## TECHNICAL REVIEW COMMITTEE

##### B1. Review and provide recommendations to the Planning Board on the new materials for the Master Plan Phase of the Major Land Development application.

**Re: Master Plan – Supplemental Information**  
**Mt. Hope High School**  
**199 Chestnut Street**  
**Bristol, RI**  
 (Pare Project No. 23099.01)

Date: 9/30/2024 Job No.: 23099.01  
To: Diane Williamson, AICP, CFM - Town of Bristol Director of Community Development; Edward Tanner – Town of Bristol Principal Planner  
Cc:  
From: Nicole Iannuzzi, PE – Vice President (BETA Group, Inc.)  
Subject: Mount Hope High School Master Plan Review TRC Meeting October 2, 2024

**Event Parking Figure prepared by Pare  
Corporation**

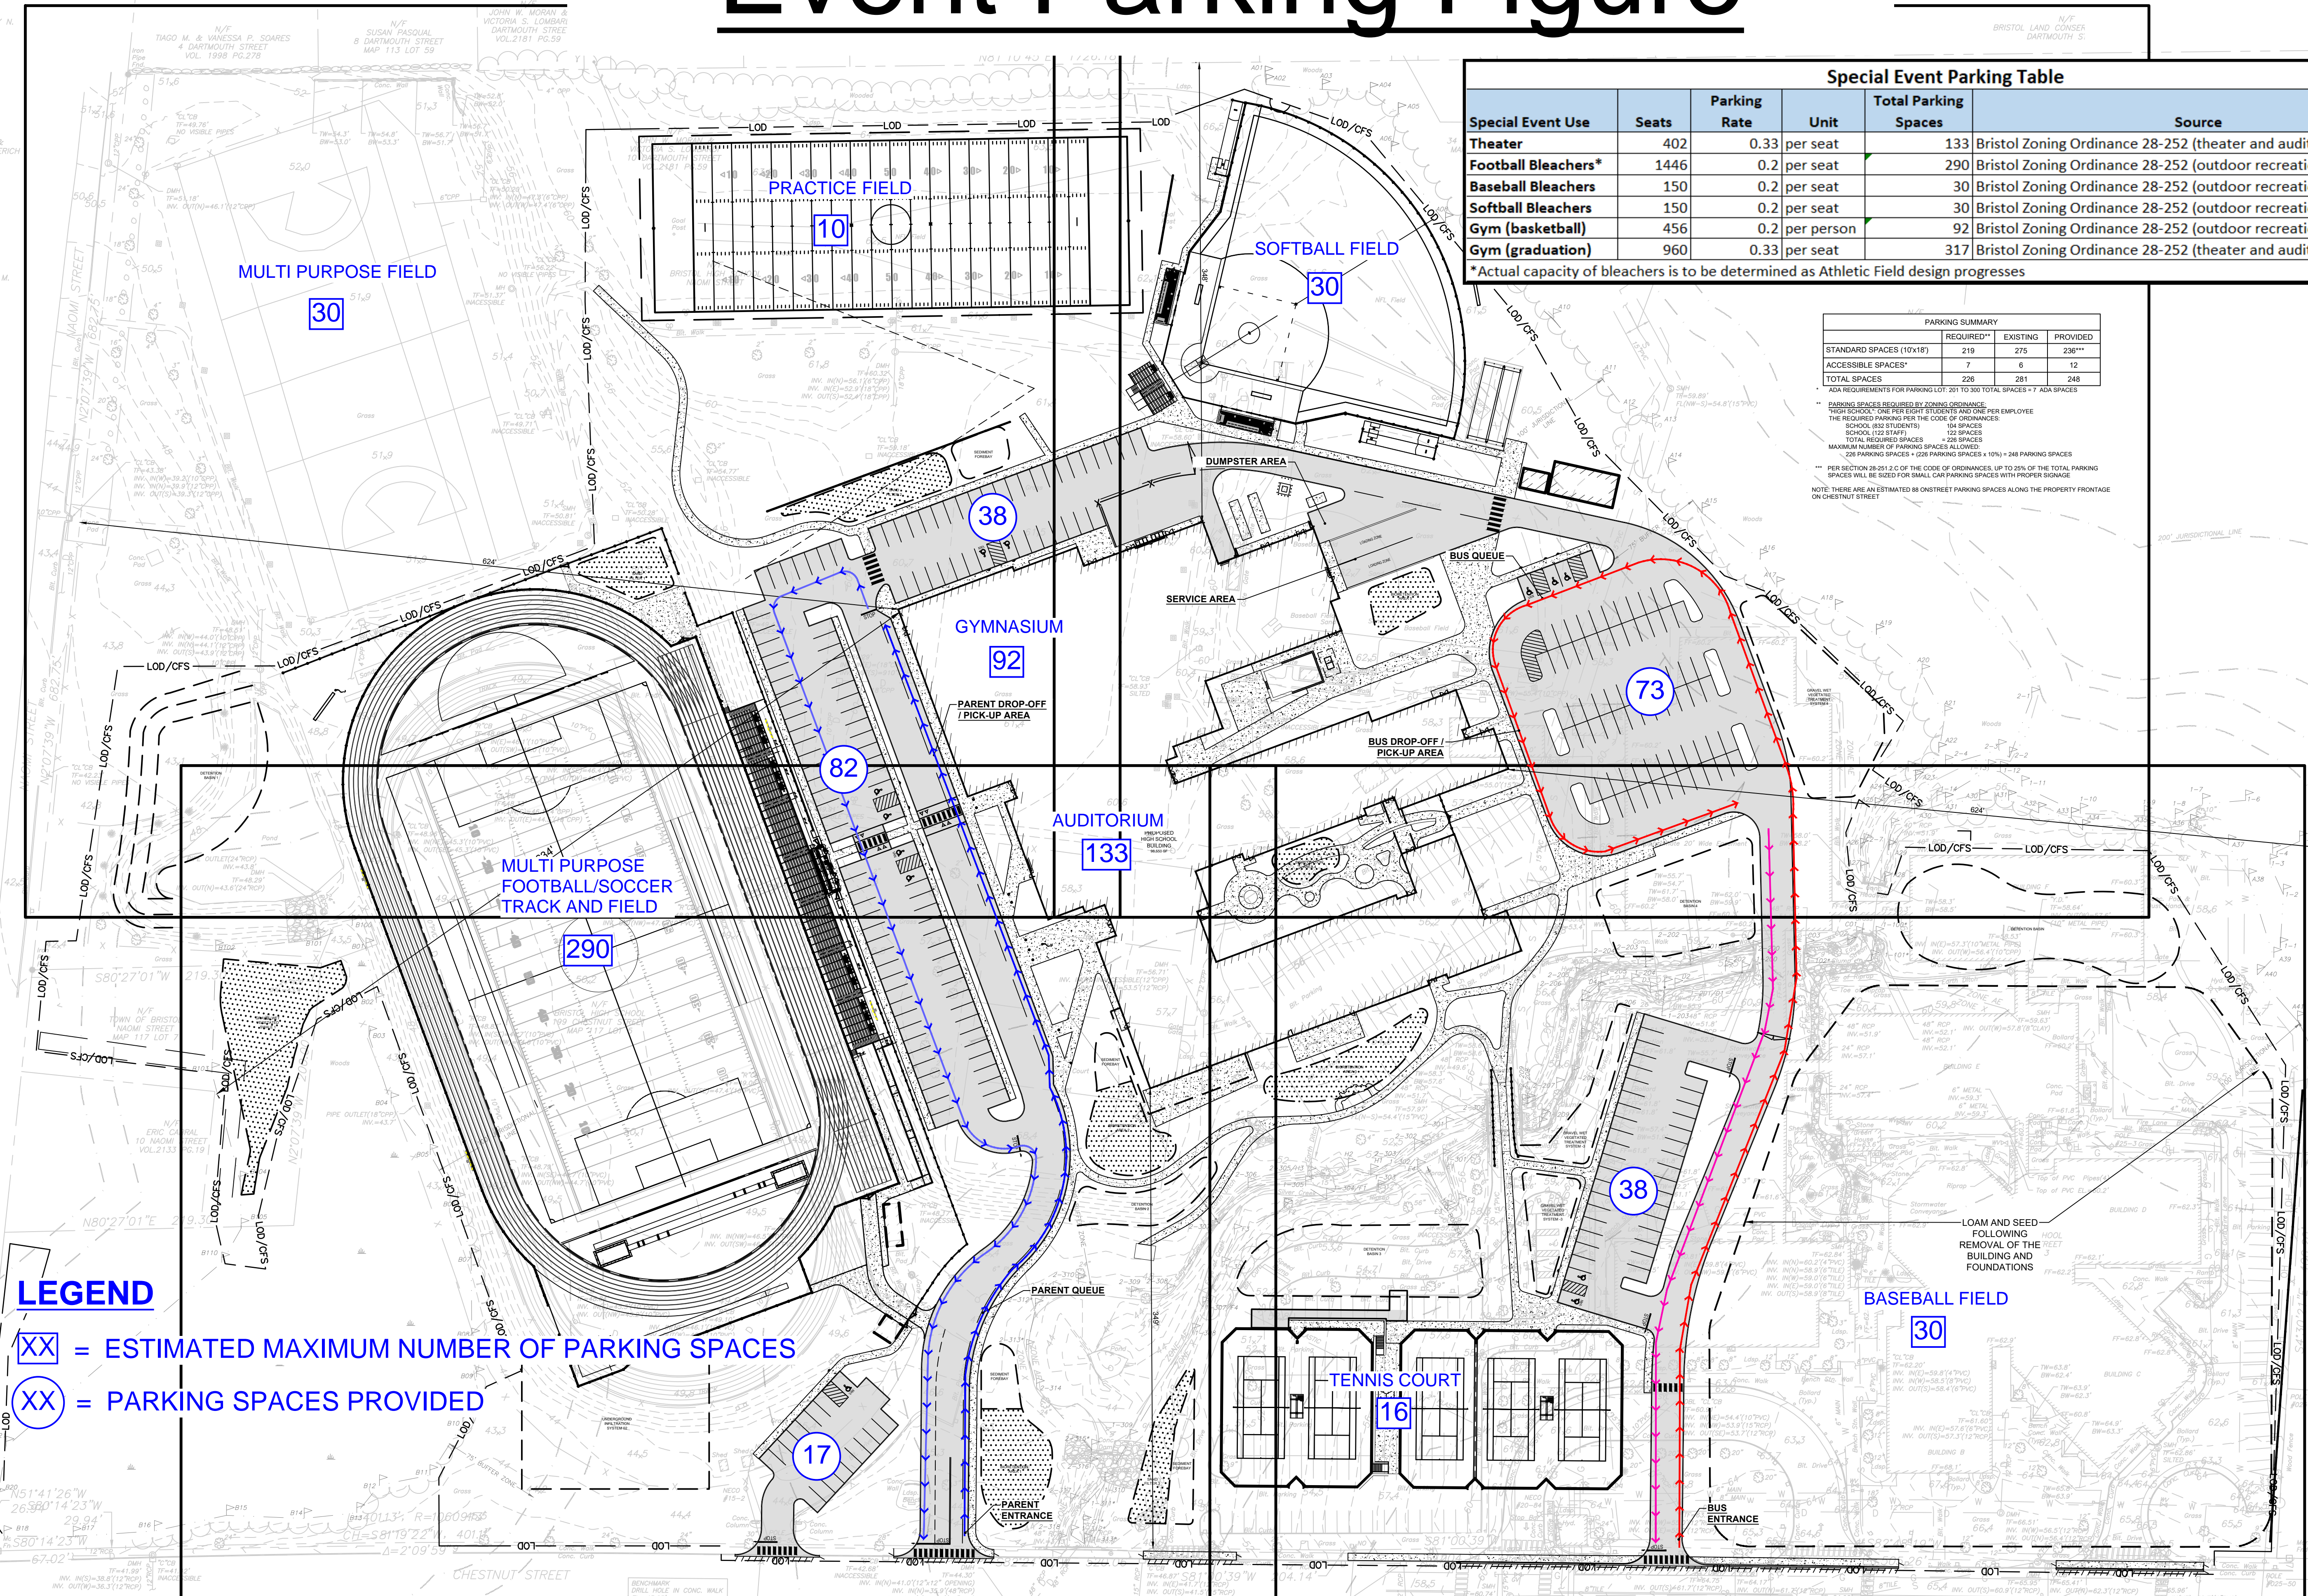
- Attachment 2, presented in the Planning Board meeting on September 12, 2024, depicts the off-street parking available for the variety of anticipated athletic and cultural events.

- During events, additional parking is available on Chestnut Street and within a gravel lot at Paull Park. These two locations offer the public an additional 100 parking spaces.

OVERALL  
CONCEPT PLAN  
DRAWING NO.:  
**C3.0**  
SHEET NO. 5 OF 10

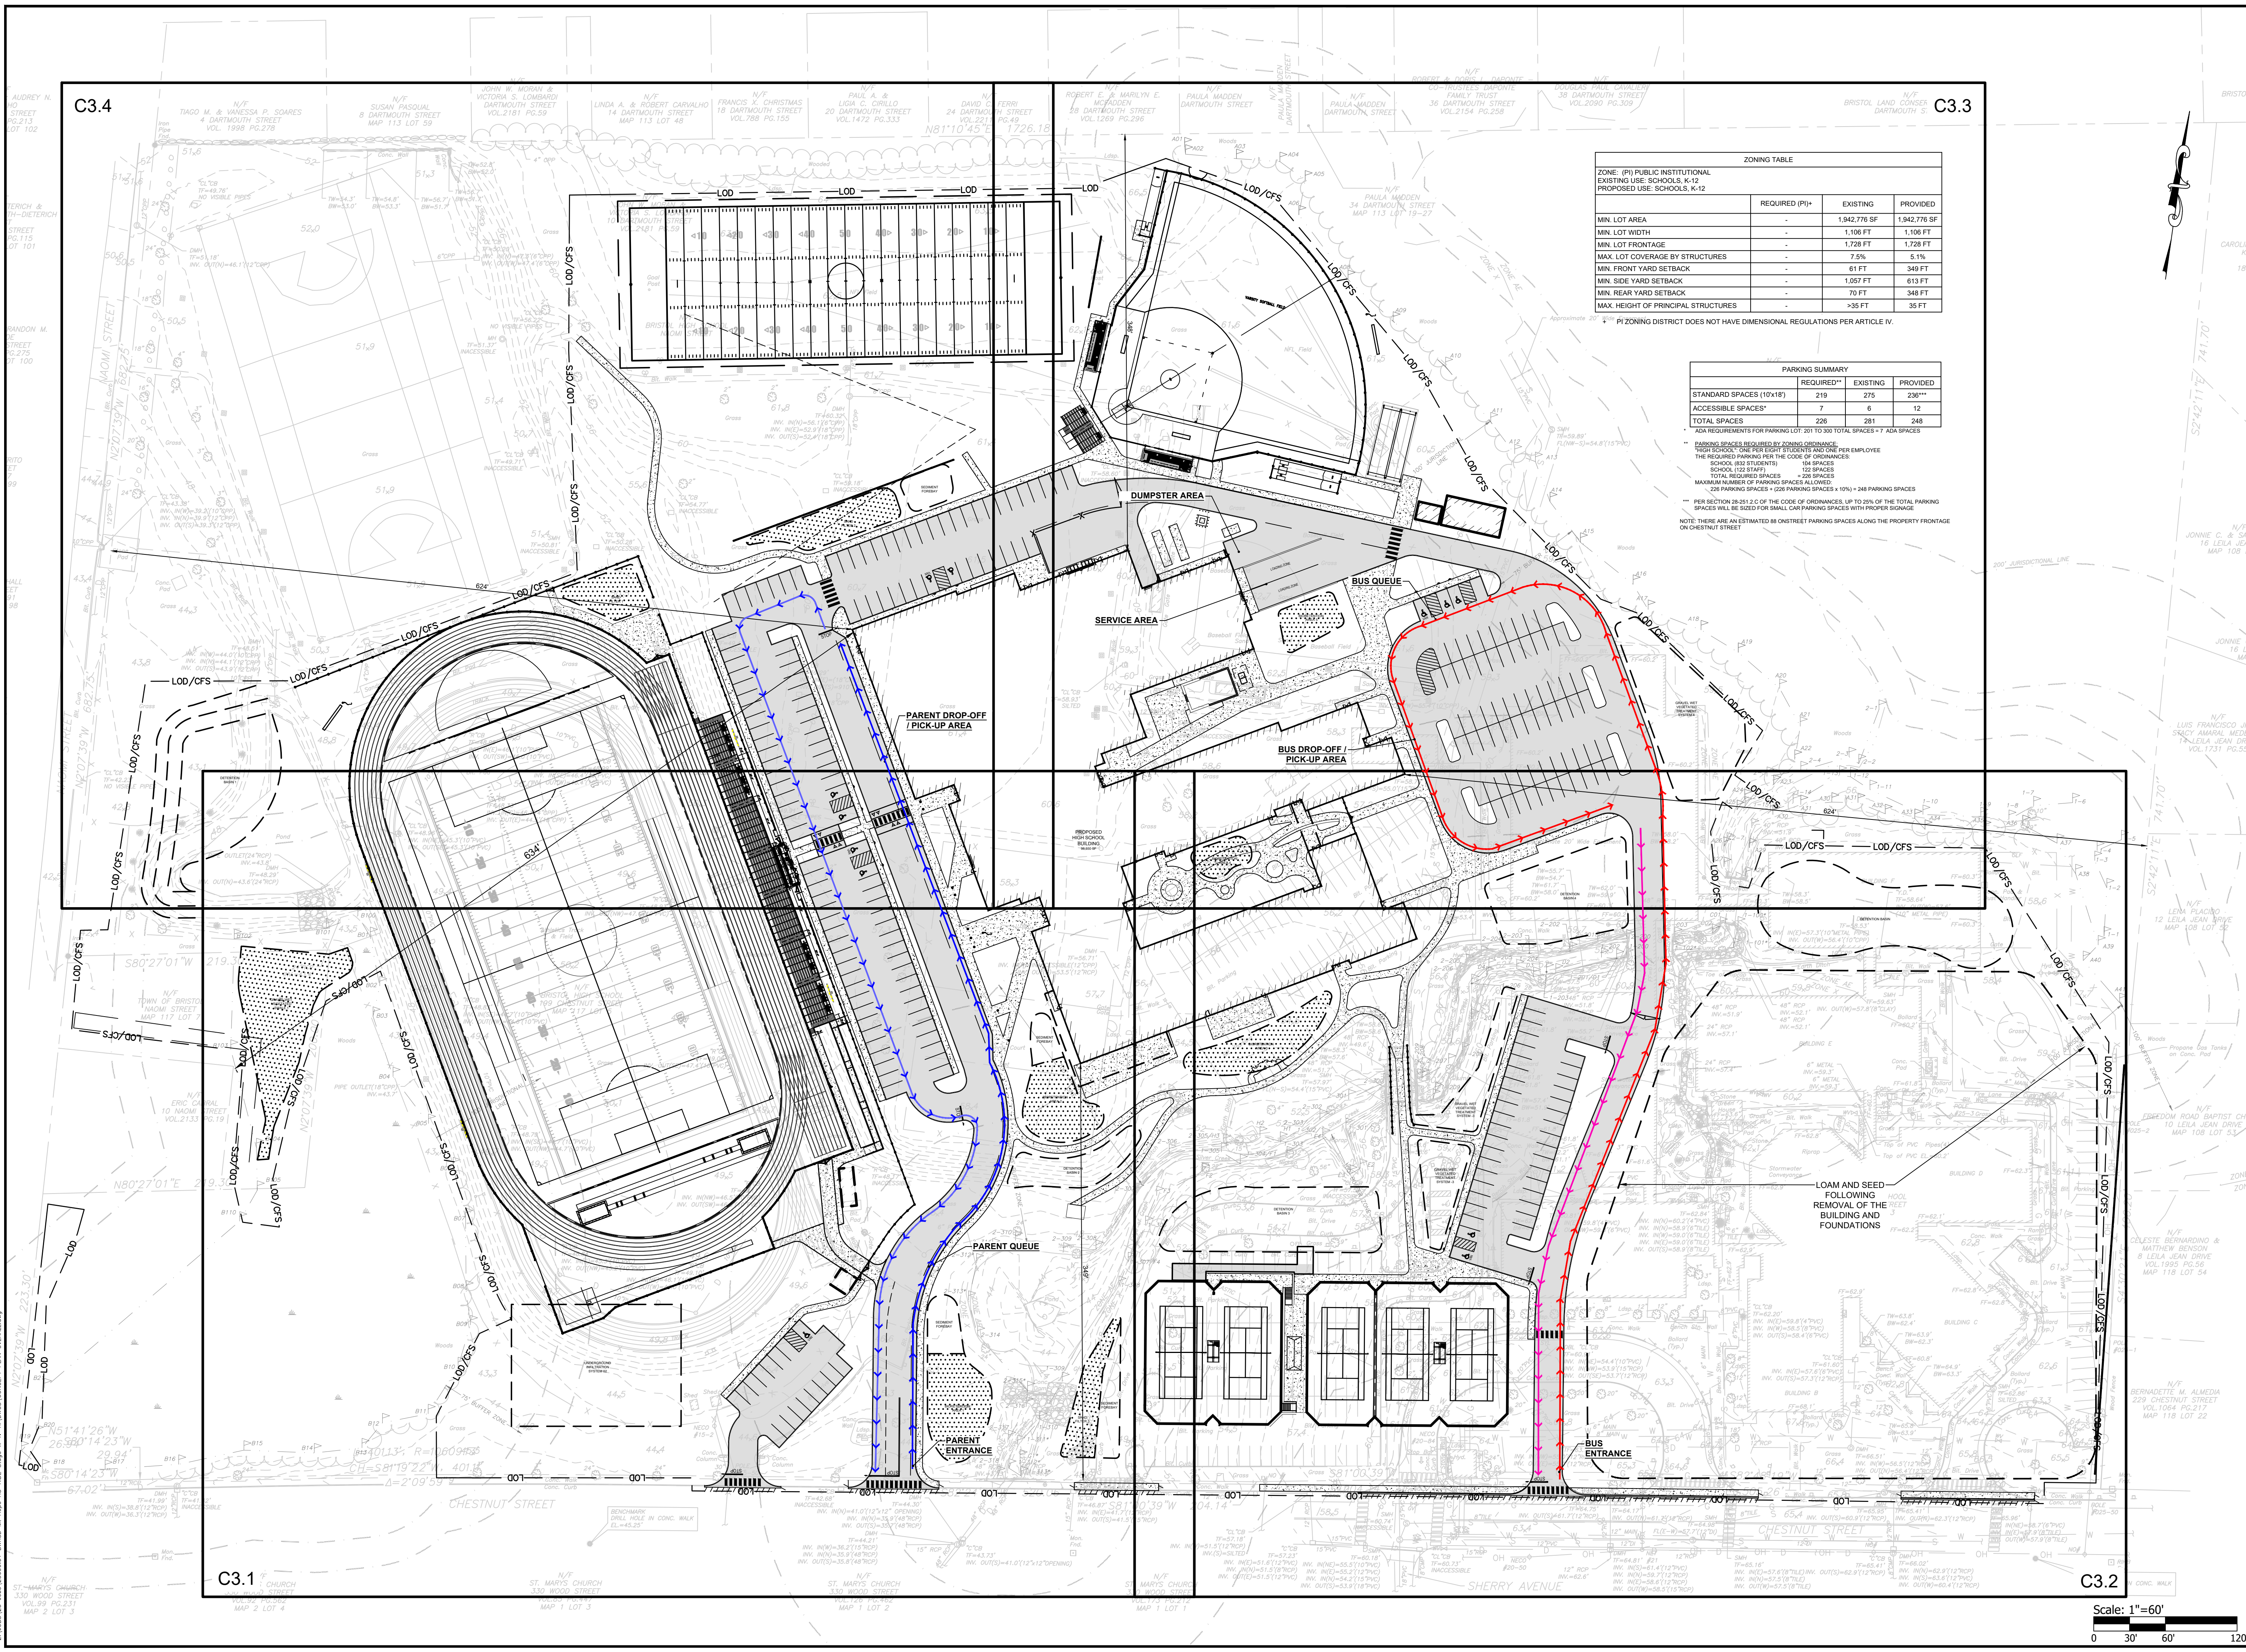
In response to concerns regarding the proposed 240 off-street parking spaces, the revised Master Plan Sheet C3.0 proposes 248 parking spaces. The existing high school has 281 parking spaces. BWRSD has determined that 248 parking spaces satisfies the future high school needs for the school day by providing parking spaces for the 122 staff members, 10 visitors and 116 students who are permitted to park on site. BWRSD anticipates the Master Plan will provide adequate parking spaces for the high school’s operations and special events. Supplemental information to support the number of proposed parking spaces is included below:

- In an effort to reduce impervious surface, meet the Rhode Island Department of Education (RIDE) standards, and provide adequate parking distribution around the site, BWRSD determined that the 248 parking spaces is adequate for the operations of the school during the school day and special events.

- Per the Code of Ordinance section 28-252.c, the high school is required to have a minimum of 226 off-site parking spaces. Per the Town of Bristol Code of Ordinance section 28-252.a “the maximum number of off-street parking spaces allowed for any lot or use shall not exceed ten percent”. Based on section 28-252.a the maximum parking spaces is 248 off-street parking spaces. The Master Plan is revised depicting an additional 8 parking spaces to be at the maximum capacity for the site per the Code of Ordinance.
